Bulletin Level: 3*

Subject: Propane Burnisher Improvement

Models Affected: PBU 21KBCAT (Model 56381402), PBU 21KB (Model 56381404), PBU 27KB (Model 56381405), PBU 27KBCL (Model 56381406), PBU 27KBCAT (Model 56381407), PBU 27KBCATCLDC (Model 56381408), PBU 27KBCATCLDC (Model 56381409), PBU 21KBCATCLST (Model 56381410), MPS-1721 (Model 56381412), MPS-1727 (Model 56381413)

Figure 1

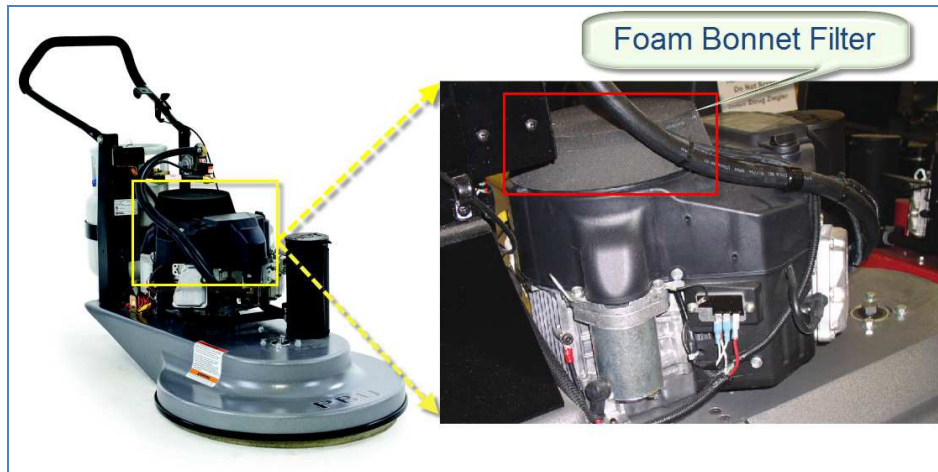
Issue: Hotter than normal engine exhaust temperatures after a small amount of run time.

Cause: The engine fan dust bonnet was found to have lower than specified flow for the air used to cool the engine.

- 1) Remove and discard the foam bonnet filter located on top of the machine (**Fig. 1**). The machine can be operated normally in this manner without threat of harm to the machine, as this bonnet filter is only designed to keep debris out of the engine. Order an upgraded bonnet filter (**Part No. 56382683**), (**Fig. 2, below**) if machine has been identified as one of the affected units.
 - To avoid confusion, any outdated bonnets (**Part No. 56381380**) remaining in dealer stock should be immediately removed, and our Customer Service Department contacted for return authorization.

On 11/04/2011, effective with serial number 3000083761, models shown above currently in production will be fitted with the updated filter (**Part No. 56382683**). All previous versions of this filter have been removed from stock.
